BAGHDAD INTERNATIONAL AIRPORT
POWER SYSTEM ENHANCEMENT
BAGHDAD, IRAQ

SUSTAINMENT ASSESSMENT

SIGIR PA-07-097
APRIL 26, 2007

SUBJECT: Report on Baghdad International Airport Power System Enhancement, Baghdad, Iraq
(Report Number SIGIR PA-07-097)

Site Photo 5. Cummins generator sets (Photo provided by USAID)

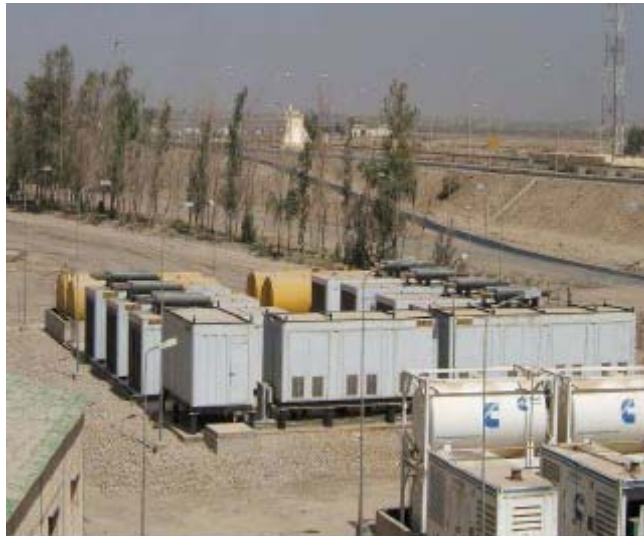
8. Page 5, site photo 5: The generators pictured are Caterpillar, not Cummins.
9. Page 9, first paragraph, fourth sentence: We recommend that the sentence which reads “However, the BIAP power plan management claimed that the commissioning and startup of the GE generators sets were not completed and were not accepted” be revised to read as follows: “During SIGIR’s March 3, 2007 site visit, the BIAP power plant manager indicated that commissioning and startup of the GE generators sets were not completed and that these generators were not accepted by the GOI. However, information presented by USAID verified that these generators were fully installed and commissioned at the project’s completion and were included in the package of 17 generators USAID turned over to the Government of Iraq under the project.”

8. **USAID Comments.** “Page 5, site photo 5: The generators pictured are Caterpillar, not Cummins.”

SIGIR Response. Site Photo 5 shows Cummins generators, not Caterpillars.
